6575A-09

S E R V I C E N O T E

**6575A - DC POWER SUPPLY, 0-120 V, 0-18 A, 2160 W.
MANUALLY CONTROLLED**

The four filter capacitors circuit reference (C416-C419) on the A4 AC input board starts leaking electrolyte

Situation:

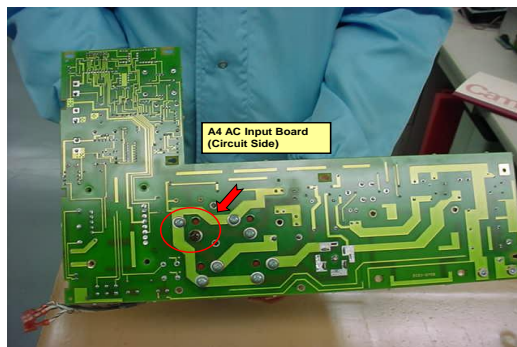
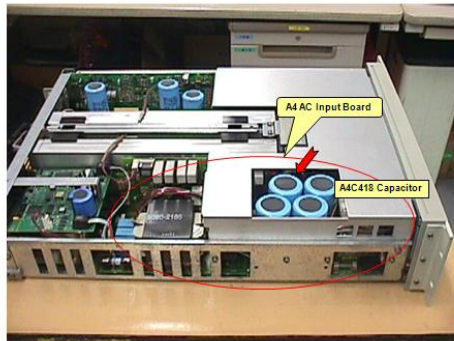
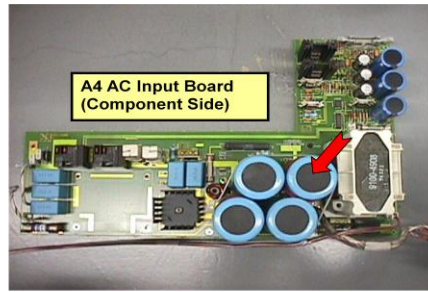
The four filter capacitors circuit reference (C416-C419) on the A4 AC input board starts leaking electrolyte - not through the pressure valve in the bottom as one would expect but through one of the terminal screw bushings.”

The screw P/N 2680-0217 length currently being used was not considered and the length was overlooked. The screw length is 0.375 inches long. We have found that the screw can be 0.055 inches too long and may bottom out causing the tapped hole in the header of the capacitor to become cracked or become broken.

When this happens the electrolyte will slowly leak out over time, and cause the defect described. This situation is even worse due to the capacitor is mounted with the header face down. If the capacitor was mounted header face up a cracked or broken header would not have caused this problem, the electrolyte could not leak out.

1. All affected models and tested assemblies WIP (Work In Process), FGI (Finished Goods Inventory) at SPO (Support Parts Organization) & AMC (Asian Manufacturing Center) has been inspected for capacitors with damaged headers due to the incorrect screw
2. When this repair is being done all of the hardware described above should be replaced (It is NOT recommended that any of the hardware be reused)
3. The following figures can be used when doing the repair.
4. Inspect the assembly as described below.
5. The last figure will aid in the reassembly of the hardware and the capacitors.
